**SUBJECT:** Savannah River Site's Responses to the Regulatory Comments on the Effectiveness Monitoring Report (EMR) for the C-Area Groundwater (CAGW) Operable Unit (OU) Removal Action (U) - July 2022 through June 2023 (SRNS-RP-2023-00913, Revision 0, October 2023) SEMS Number: 82

**SRS Responses to SCDHEC Comments on the Effectiveness Monitoring Report (EMR) for the C-Area Groundwater (CAGW) Operable Unit (OU) Removal Action (U) – July 2022 through June 2023, SEMS Number: 82, SRNS-RP-2023-00913, Revision 0, October 2023**

**SRS Responses to EPA Comments on the Effectiveness Monitoring Report (EMR) for the  
C-Area Groundwater (CAGW) Operable Unit (OU) Removal Action (U) –  
July 2022 through June 2023, SEMS Number: 82,  
SRNS-RP-2023-00913, Revision 0, October 2023**

Revised Figure 15 (shown as Figure 17 in the Rev. 0 EMR). CRW023C Post-RA Groundwater Trends

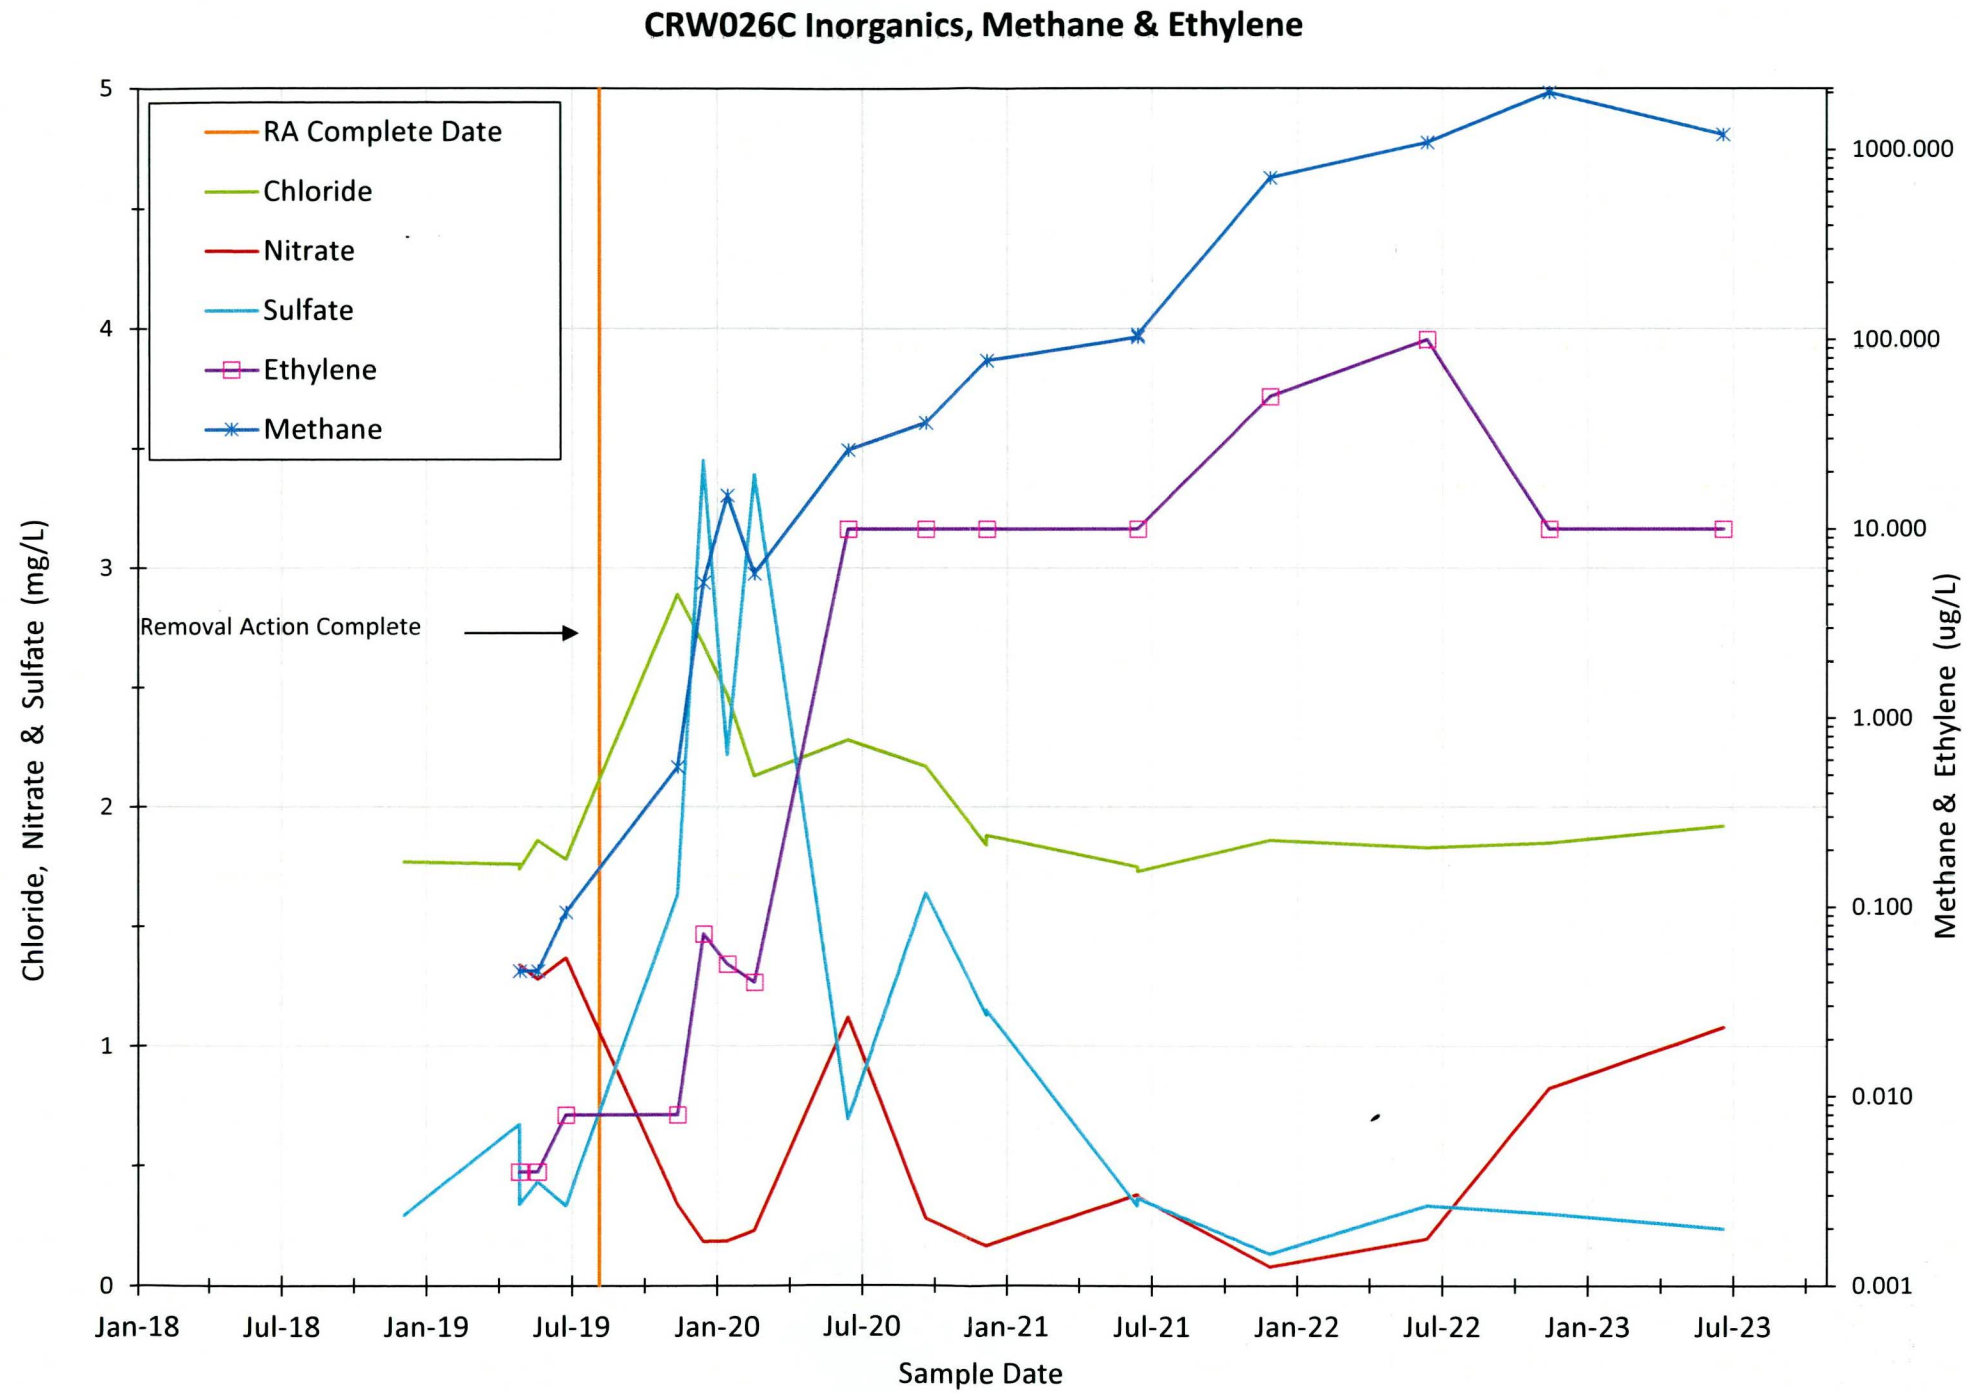
- 4. Figure 17, CRW023C Post-RA Groundwater Trends, Page 51 of 117:** The 2Q23 data for chloride, nitrate, and sulfate are not presented on Figure 17. For example, the text in Section 3.4.1.7 (Chloride, Nitrate and Sulfate) notes that nitrate concentrations have been increasing since 2022, but Figure 17 does not include the concentrations reported for nitrate (i.e., 1.4 ug/L and 1.43 ug/L for CRW023C in 2Q23) in Appendix A (CAGW OU NTC RA Analytical Data 2022-2023). *Please revise Figure 17 to include the 2Q23 data for chloride, nitrate, and sulfate.*

**The chloride, nitrate and sulfate trends for CRW023C are shown on the attached revised Figure 15 (shown as Figure 17 in the Rev. 0 EMR), and includes the 4Q22 and 2Q23 data. The next EMR will reference the correct figure for this section. No change to the current report is proposed.**

Revised Figure 16 (shown as Figure 18 in the Rev. 0 EMR). CRW026C Post-RA Groundwater Trends

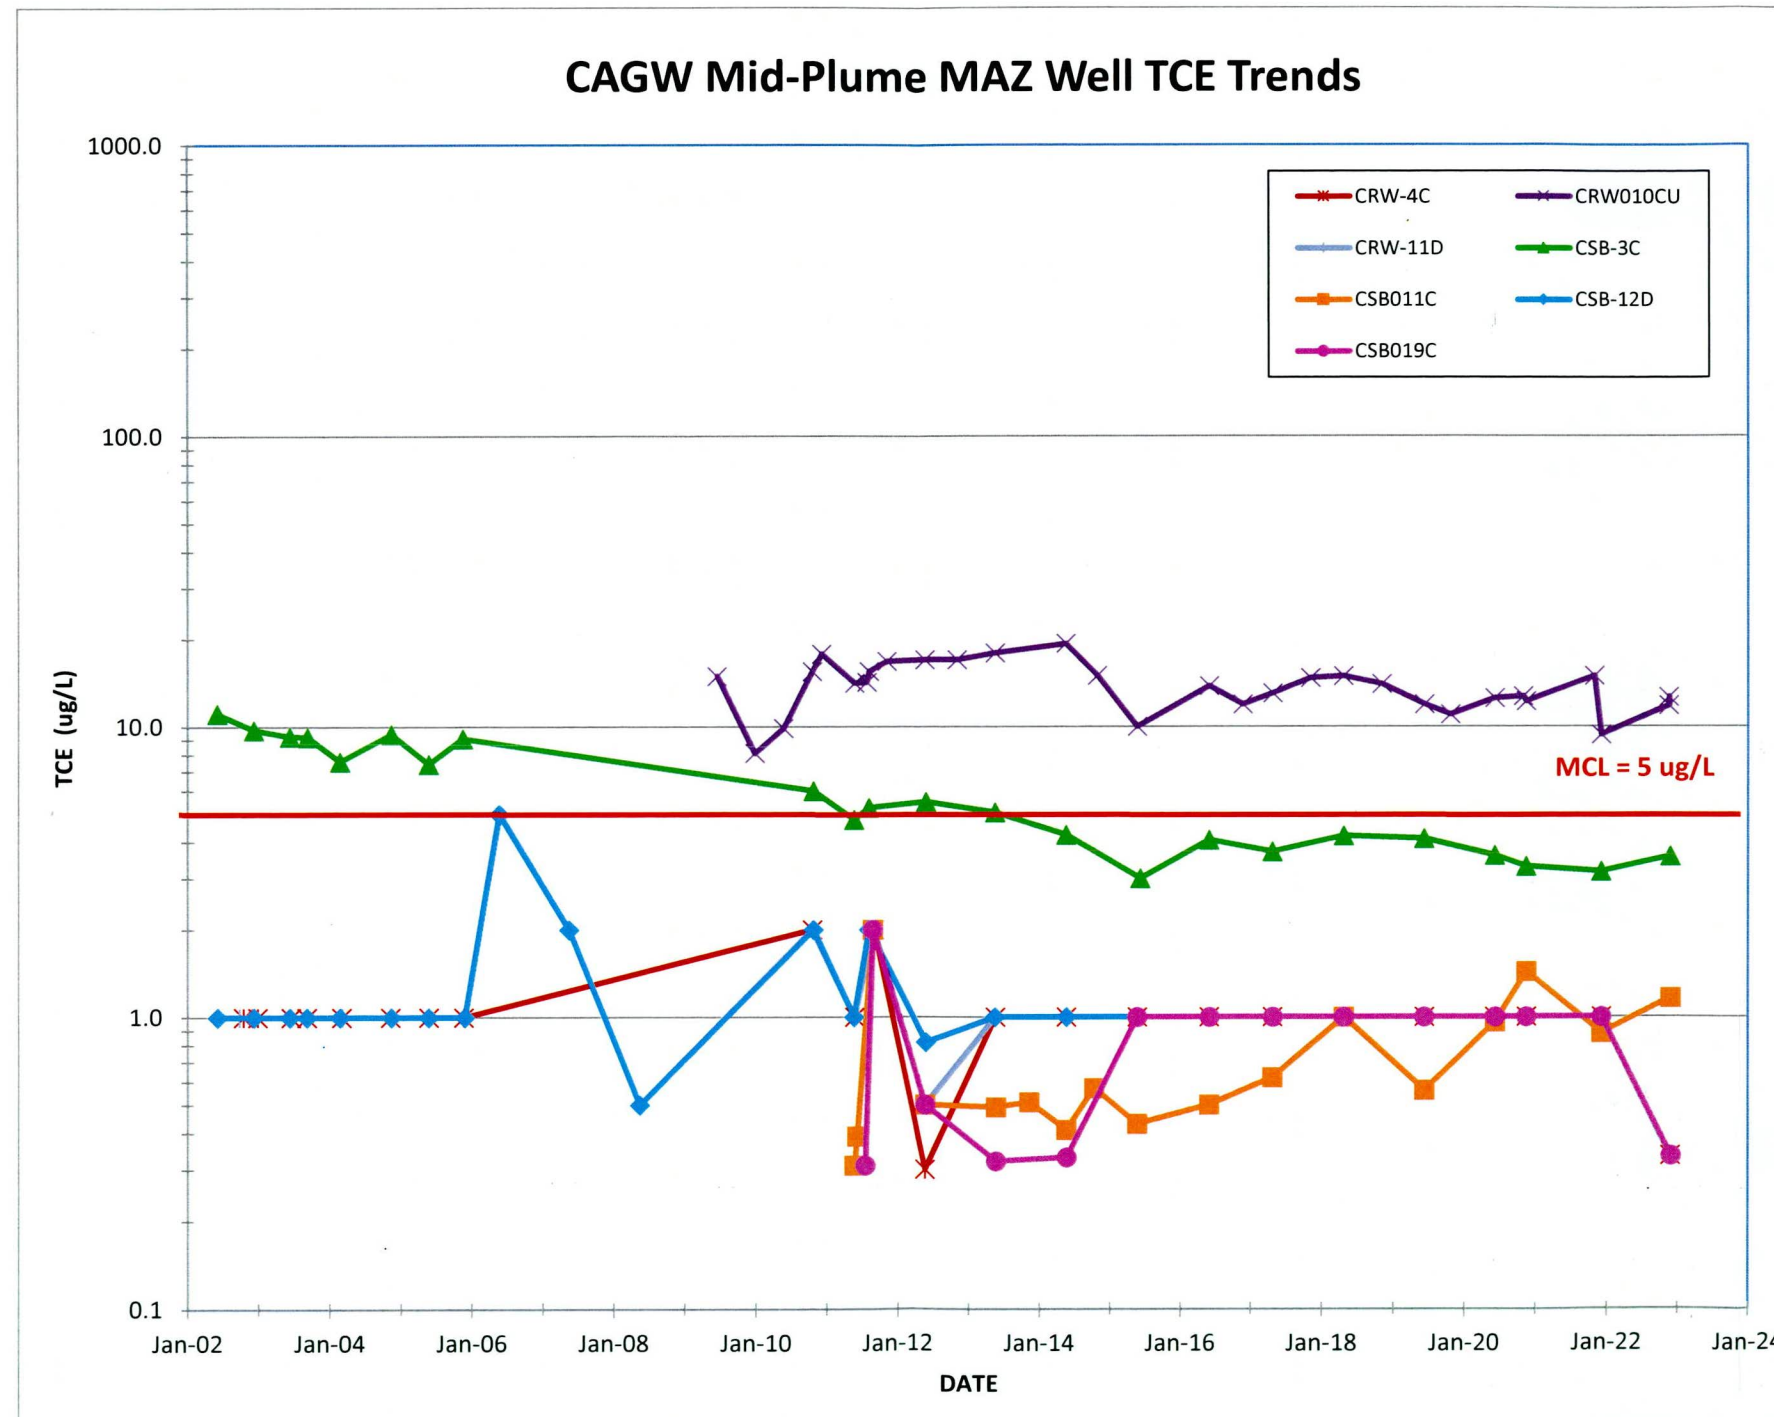
2. The numbering of the figures referenced in the text is inconsistent with the figures provided in the EMR. For example, in Section 3.4.1 (CAGW OU NTC RA), the discussion of the results for background wells CSB 15D and CSB020C references Figure 11, but the data for these background wells are provided in Figure 13 (CAGW RA Peripheral Stations TCE Trends). As another example, Section 3.4.1.6 (Methane) references Figures 15 and 16 for the methane results, but methane results are shown in Figures 17 and 18. *Please revise the EMR to resolve the discrepancies in the figure numbers referenced in the text and provided in the EMR.*

Section 3.4.1 (CAGW OU NTC RA) in the discussion of the results for background wells CSB 15D and CSB020C, currently references Figure 11 but only for TCE results. Figure 13 contains the co-metabolic enzyme data for well CRW026C. Figures 15 and 16 depict methane results, but only for wells CRW023C and CRW026C, respectively. Please see the attached corrected Figures 15 and 16 (i.e., Figures 17 and 18 in the Rev. 0 EMR). No change to the current report is proposed.
